Bulletin Date: 12/24/2014		Bulletin Effective Date: 12/24/2014	
Title: SPIL_QFN-4x4_Tray change			
Originator: Paranidharan Rengarajan		Phone: +65 6511 7735	Dept: Supplier Management
Customer Contact: Kathy Haggart		Phone: (512) 532-5261	Dept: Sales
Bulletin Details			
Description: Silicon Labs is pleased to announce a change is being made to the shipment media for Si40xx/Si43xx/Si44xx QFN-4x4 devices. Per the effective date of this PCN, there will be a change in tray supplier from Sunrise QJ-012 to Hwa Shu EAM040411. The tray dimensions for the current and new tray are identical, except the new tray’s cavity design and wall size have been optimized to prevent unit tilt and unit misplacement issues. Please refer to “ Appendix A ” for the comparison details between Sunrise QJ-012 & Hwa Shu EAM040411 trays. Refer to “ Appendix B ” for the tray drawings of both Sunrise QJ-012 & Hwa Shu EAM040411 trays.

Sunrise tray (QJ-012)

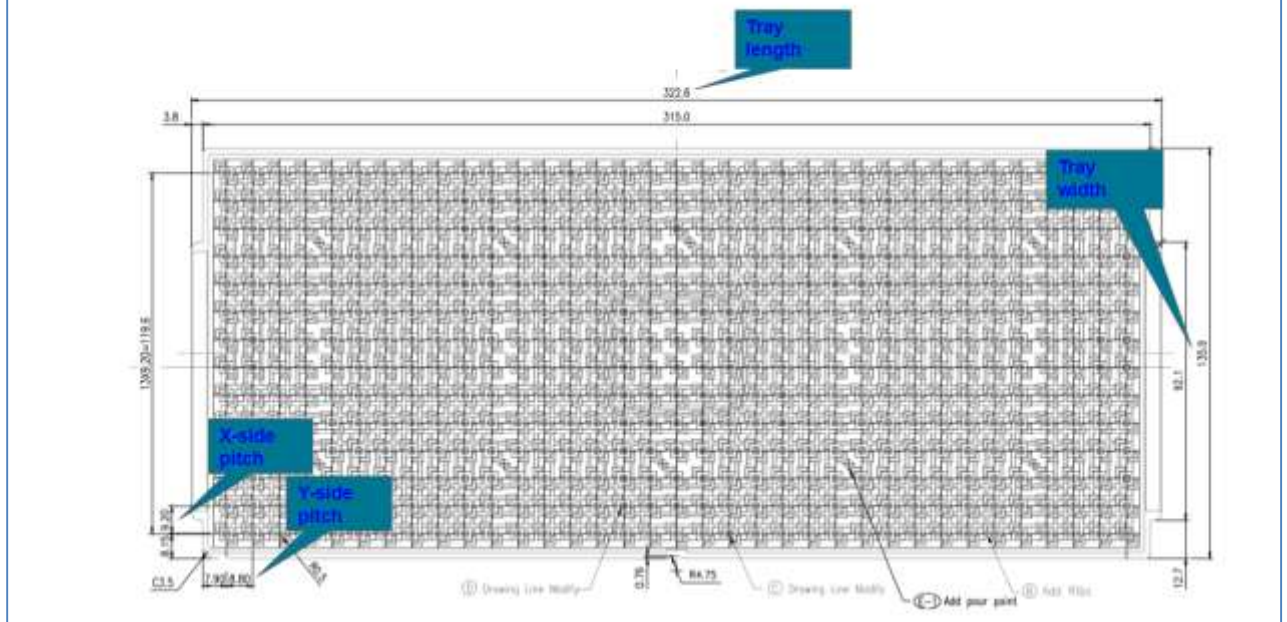
Sunrise and Hwa Shu tray out dimensions compare

Item	Sunrise tray (Tray drawing: QJ-012)	Hwa Shu tray (Tray drawing: EAM040411)	GAP
Tray Length	322.6mm	322.6mm	NO
Tray Width	135.9mm	135.9mm	NO
X-side pitch	9.20mm	9.20mm	NO
Y-side pitch	8.80mm	8.80mm	NO
